TRI-PARTY AGREEMENT

Change Notice Number TPA-CN- 0835	TPA CHANGE NOTICE FORM	Date: 01/31/19
Document Number, Title, and Revision: DOE/RL-2014-42-ADD1, 300-FF-5 Operable Unit Remedy Implementation Sampling and Analysis Plan Addendum for Stage B Uranium Sequestration, Rev. 0 <i>1243694</i>		Date Document Last Issued: December 2016

Description of Change:
DOE/RL-2014-42-ADD1 is revised to reflect changes to the Stage B project schedule and to include analytes required for sampling discussed in section 3.2.1.

Figure 1. Stage B Uranium Sequestration Project Schedule

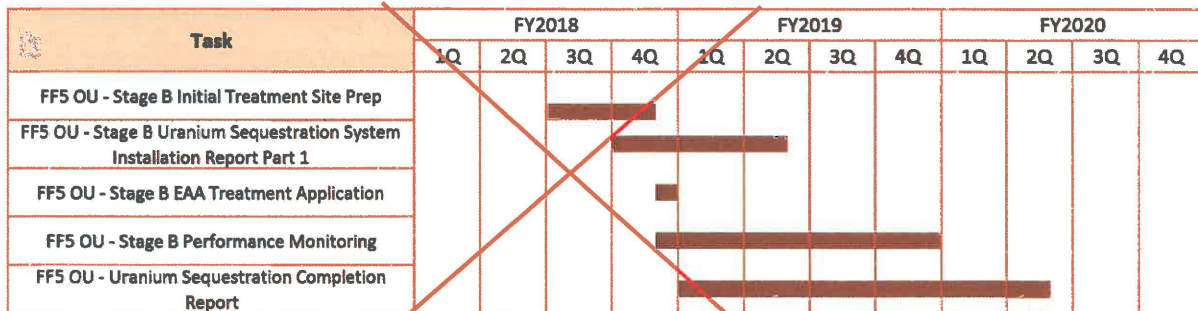
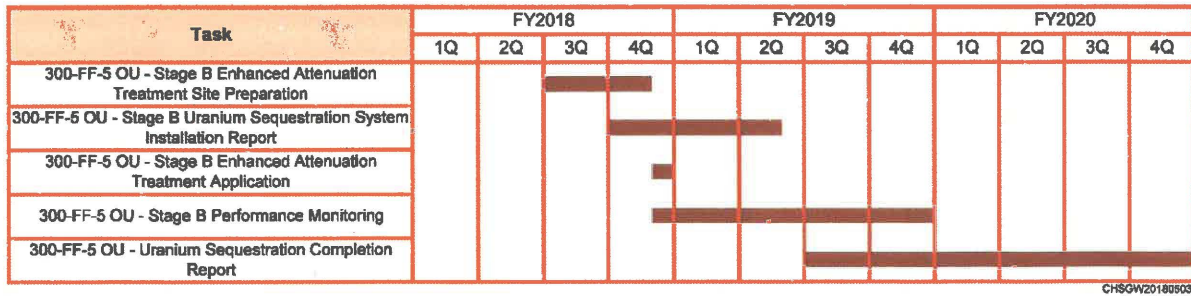
- Section 1.3 has text changes and Figure 1 has been replaced to reflect the new Stage B project schedule following one year of performance monitoring after completion of Stage B enhanced attenuation treatment.
- Table 5 is amended to add constituents arsenic, manganese, total alkalinity, and bicarbonate alkalinity for daily, weekly, and monthly groundwater monitoring as discussed in Section 3.2.1.
- Figure 6 is replaced to reflect the correct well types.

This SAP addendum will direct *Comprehensive Environmental Response, Compensation, and Liability Act of 1980* (CERCLA) remedy performance monitoring activities related to Stage B EA for the 300-FF-5 OU. The original schedule for these activities in the *Remedial Design Report/Remedial Action Work Plan Addendum for the 300 Area Groundwater* (DOE/RL-2014-13-ADD2) did not include a six-month waiting period after completion of the treatment application prior to drilling the post-treatment boreholes. This waiting period is needed to allow the geochemical reactions additional time to progress prior to analyzing the soil borings for uranium leachability characteristics. TPA-CN-700, approved in November 2015, revised the schedule to include this six month waiting period, the postponement of Stage B. In 2017, Stage B was postponed for one year. TPA-CN 0784, approved in June 2017, revised the schedule in DOE/RL-2014-13-ADD2 to include this one year postponement. TPA-CN-0828, approved in August 2018, added the one-year postponement to the schedule in this addendum. TPA-CN-0828 also extended the schedule for Stage B performance monitoring following treatment from six months to one year, consistent with this addendum. The schedule for completion of the uranium sequestration report was subsequently also extended by six months. This addendum includes the revised schedule (Figure 1).

This SAP addendum will direct *Comprehensive Environmental Response, Compensation, and Liability Act of 1980* (CERCLA) remedy performance monitoring activities related to Stage B EA for the 300-FF-5 OU. The original schedule for these activities in the *Remedial Design Report/Remedial Action Work Plan Addendum for the 300 Area Groundwater* (DOE/RL-2014-13-ADD2) did not include a six-month waiting period after completion of the treatment application prior to drilling the post-treatment boreholes. This waiting period is needed to allow the geochemical reactions additional time to progress prior to analyzing the soil borings for uranium leachability characteristics. TPA-CN-700, approved in November 2015, revised the schedule to include this six month waiting period, the postponement of Stage B. In 2017, Stage B was postponed for one year. TPA-CN 0784, approved in June 2017, revised the schedule in DOE/RL-2014-13-ADD2 to include this one year postponement. TPA-CN-0828, approved in August 2018, added the one-year postponement to the schedule in this addendum. TPA-CN-0828 also extended the schedule for Stage B performance monitoring following treatment from six months to one year, consistent with this addendum. The schedule for completion of the uranium sequestration report was subsequently also extended by six months. This addendum includes the revised schedule (Figure 1).
